City of Portland, Maine - Building or Use Permit Application

Permit No: 01-1513	Issue Date: JAN 9 2002	CBL: 238A B004001
-----------------------	---------------------------	----------------------

CASCO BAY SURGERY BUILDING PERMIT

FAX TRANSMITTAL**DATE:** January 7, 2002**ATTENTION:** Tammy Munson**COMPANY:** City of Portland, Building Inspection**FAX NUMBER :** 874-8716**SENT BY:** Anne Callender**NUMBER OF PAGES INCLUDING COVER LETTER:** 66**RE:** Casco Bay Surgery at 10 Harry Harmon/66 Hutchens Drive.

8 GUARD DETAIL
A4.2 1 1/2" = 1' 0"

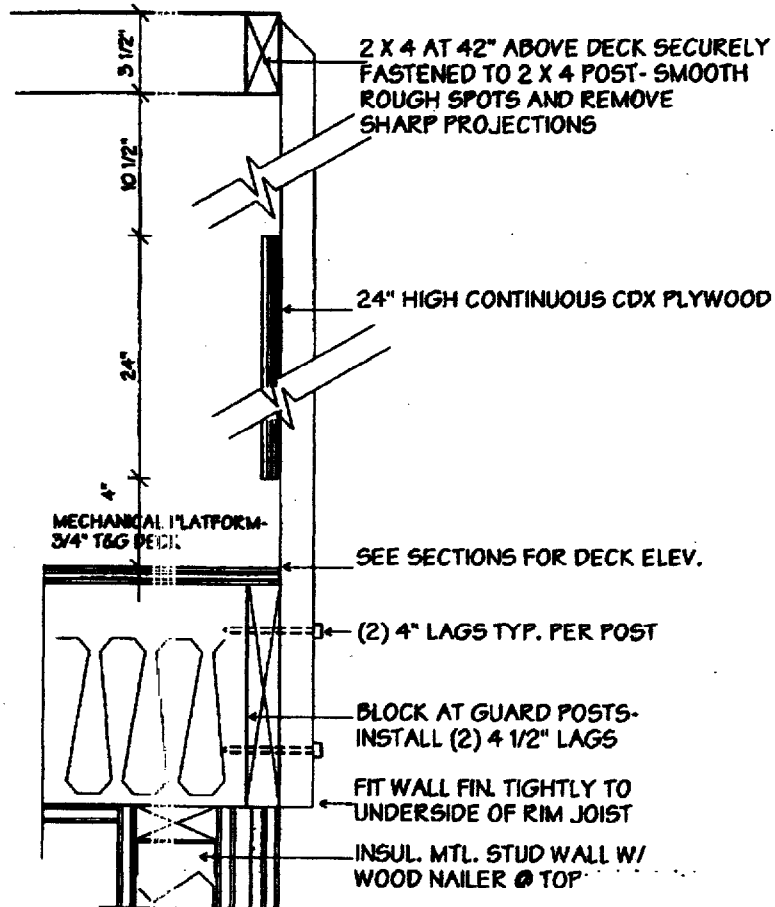
Stairs to equipment area must be 7" rise w/ 11" tread as drawn on original plan. Relayed this info to Joe Delaney of Whipple and Callender architectural firm on 01/08/2002.

Under section 1021.0 Guards, 1021.3 Opening limitations there is an exception for equipment platforms, where the guard balusters need to limit a 21" sphere from passing. So another 2x4 at the center of the guard opening detail we showed would work. I am revising the detail to use plywood and am including it in this fax.

Relayed message to Joe Delaney that stairs to equipment area have to be 7/11 as drawn on original plan. T.M.
